1 **PARK COUNTY PLANNING & ZONING DEPARTMENT**
2 Staff Report – Board of County Commissioners
3 Booher Minor Subdivision-80 (MS-80) – Public Hearing
4 Sketch Plan Review
5

7 **Applicant:** Rudi & Carla Booher

**RE: *Engineering Review of Sketch Plan
Proposed Booher Minor Subdivision (MS-80)
Lot 70-G and Lot 70-L (Resurvey) - T.55N., R.98W– Park County
Park County Road 6, Powell, Wyoming***

Figure 1: Booher MS-80 Sketch Plan

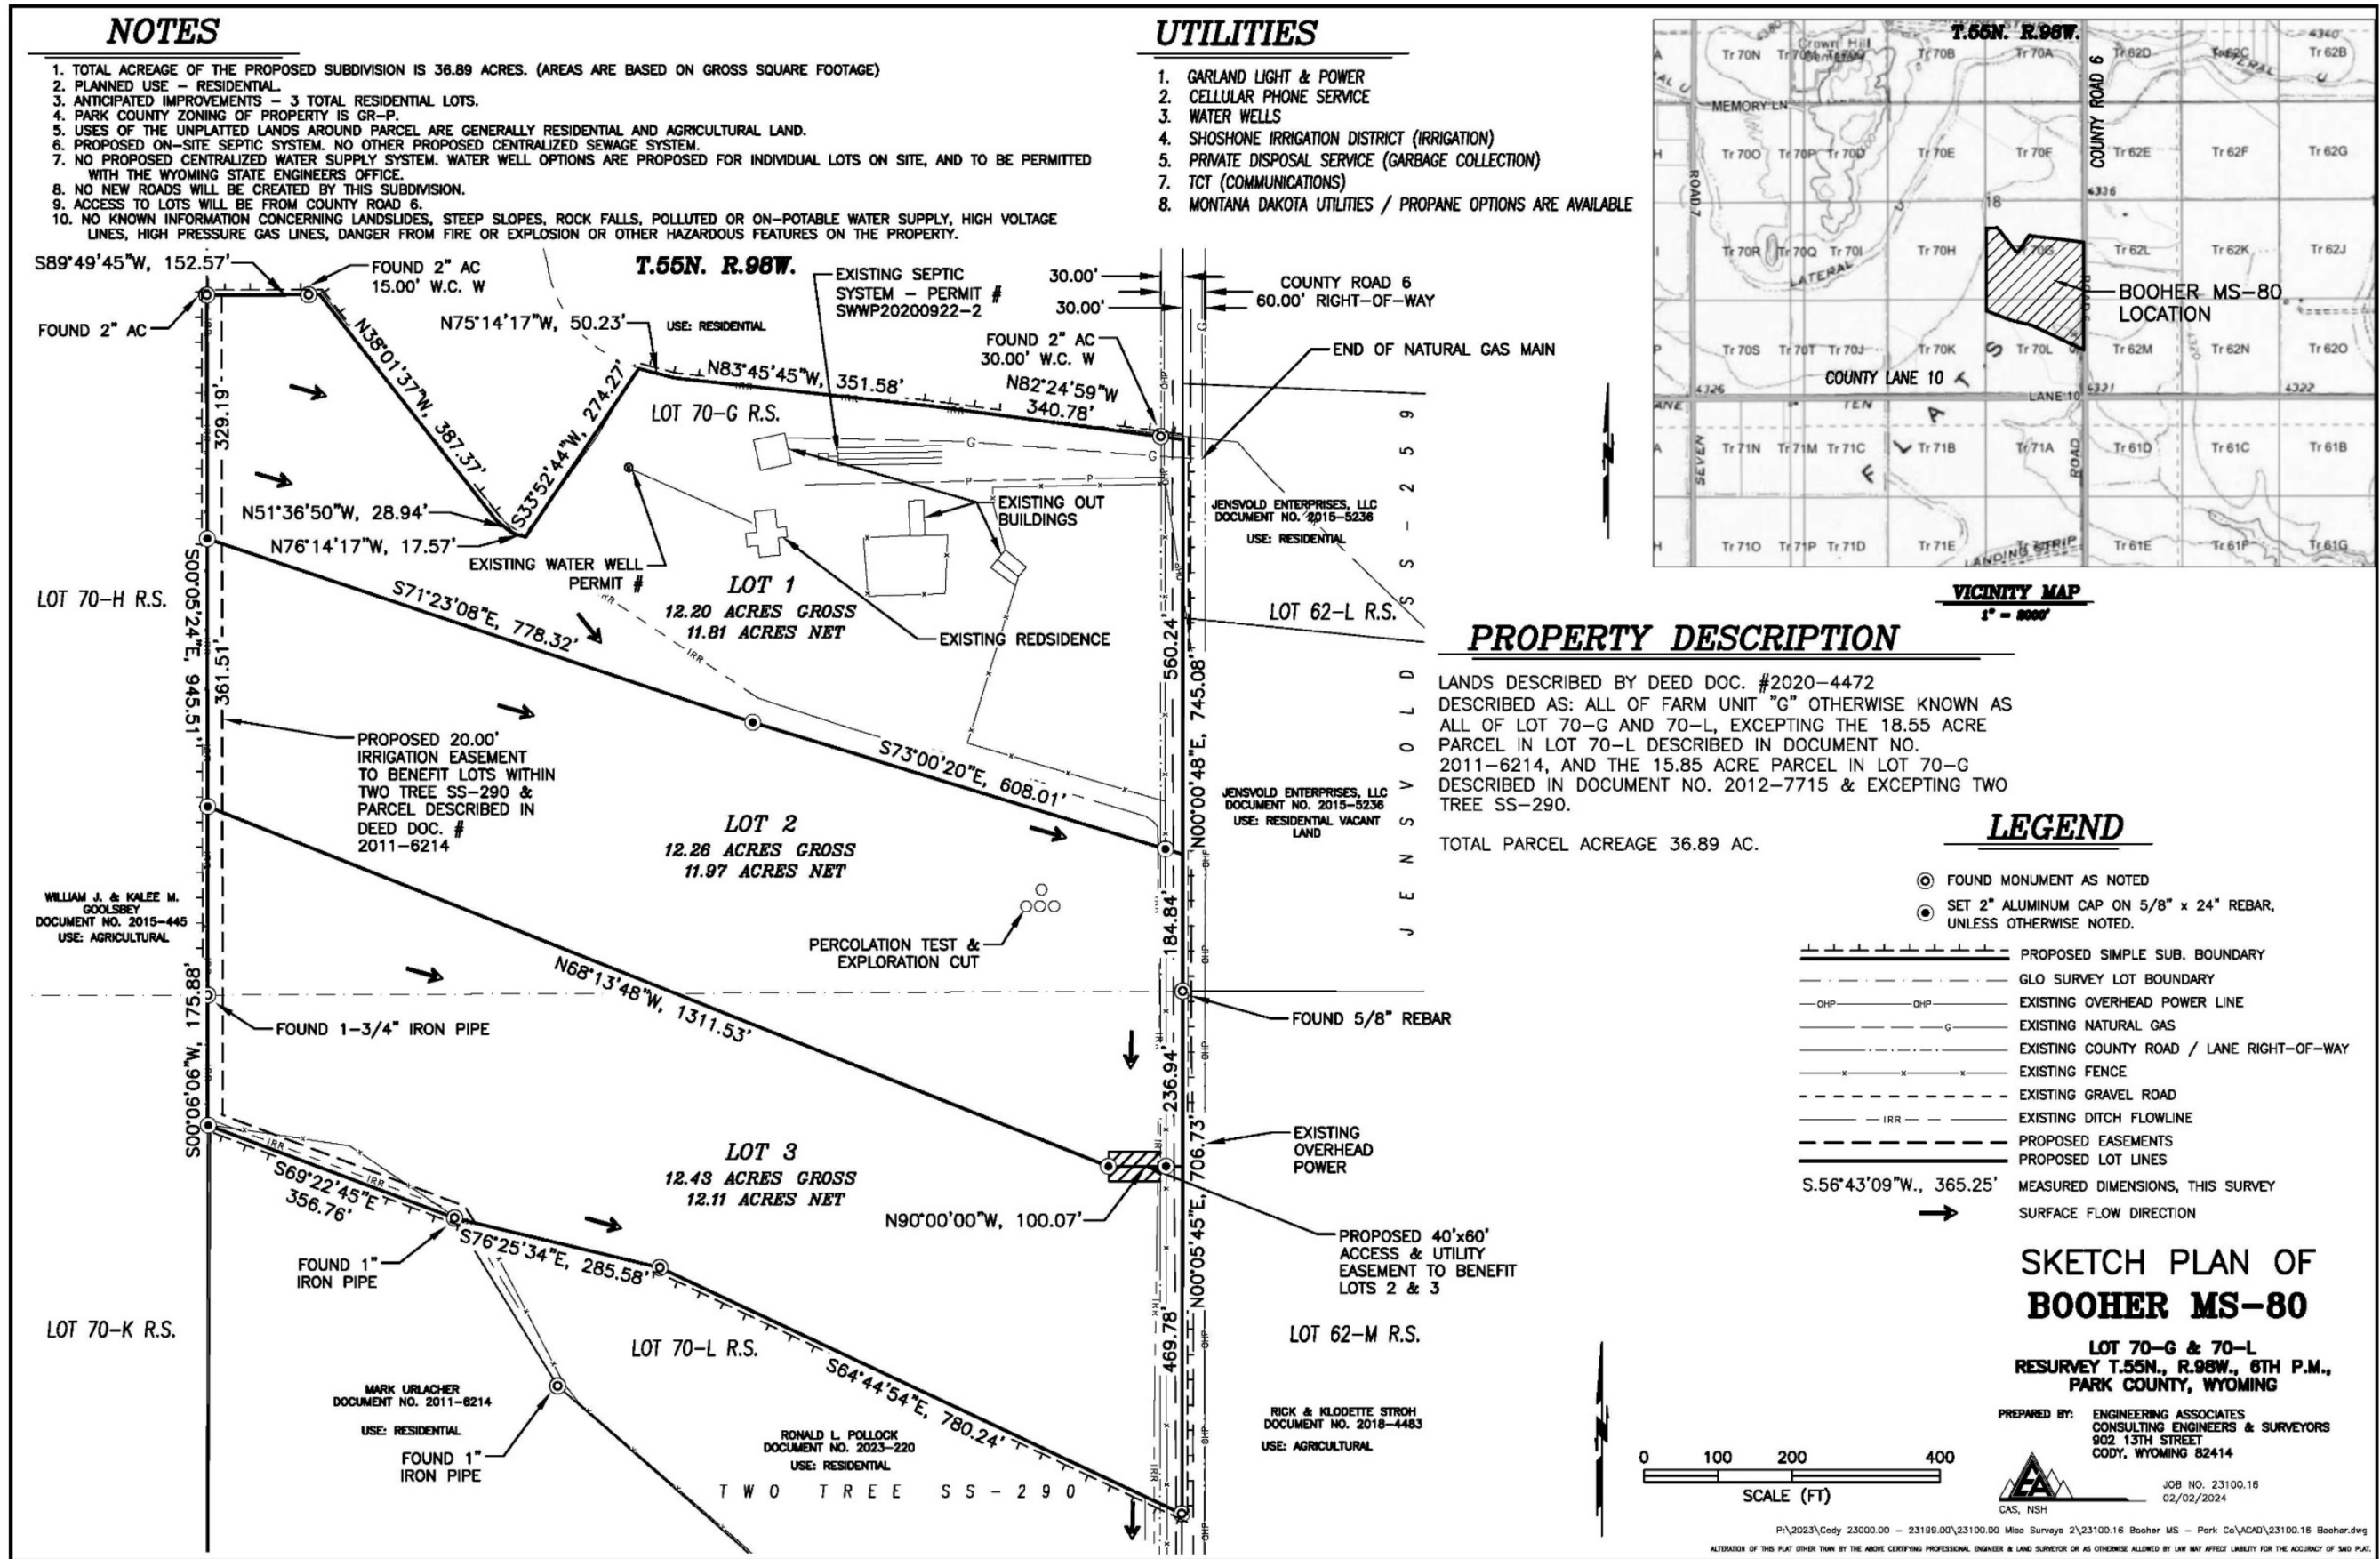
- 143
144 ➤ Proposed Lot 1 has an existing access point. The applicant has proposed
145 a shared access point for proposed Lots 2 and 3, which do not have
146 existing access. A *Right of Way Permit* to construct an access to the
147 County Road system will be required.

- 148
149 ➤ The Shoshone Irrigation District (SID) should be consulted about any
150 proposed access crossing a SID Facility. The proposed location has
151 an existing irrigation drain, which is believed to be a SID facility. SID
152 approval should indicate appropriate culvert size for the specific
153 crossing.

Noxious Weed locations (approximate and many contiguous)

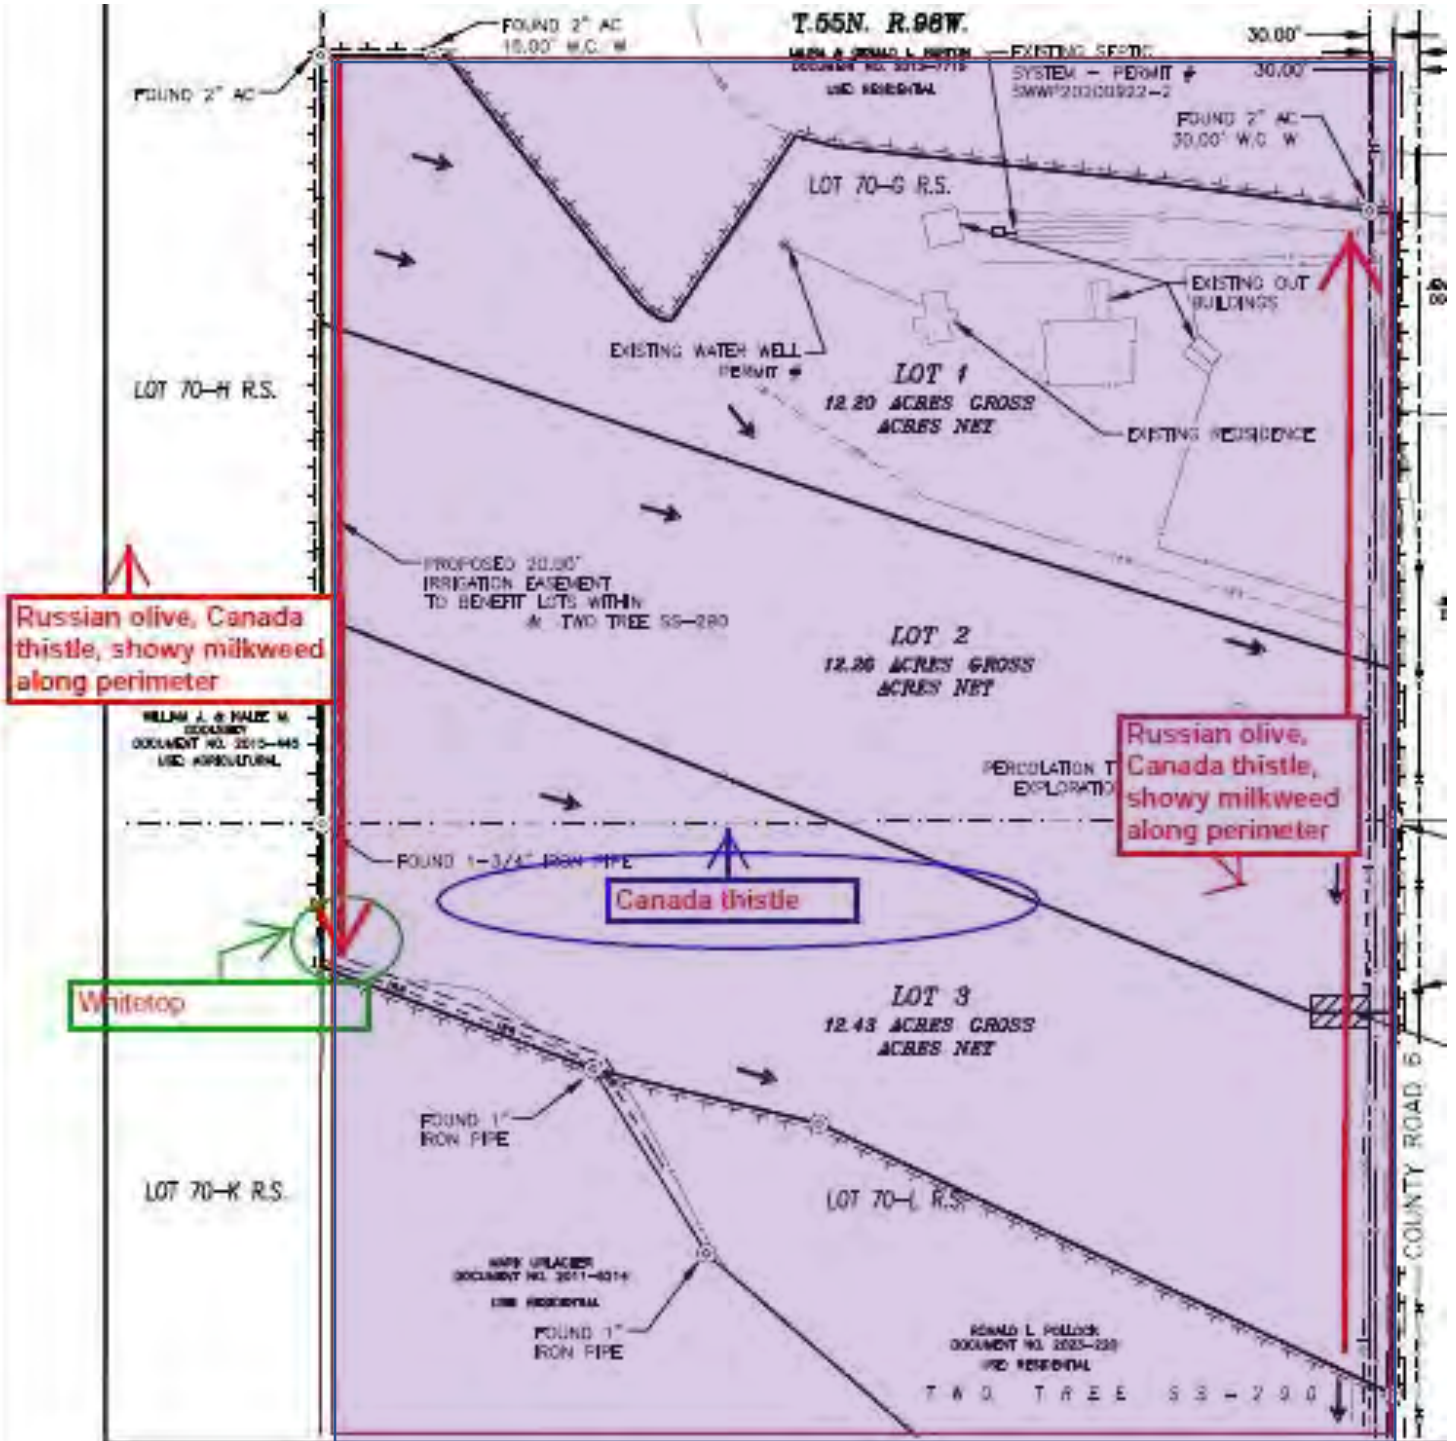
A Long-Term Noxious Weed Management Plan addressing a prevention and control program to minimize the introduction or spread of these or any noxious weeds as defined in Wyoming Statutes §11-5-101 inclusive **will be** required of the applicants. Mitigation of the noted species should commence before any further ground disturbance occurs or as conditions allow. A template of the proposed weed plan along with a copy of this correspondence has been forwarded to the applicant.
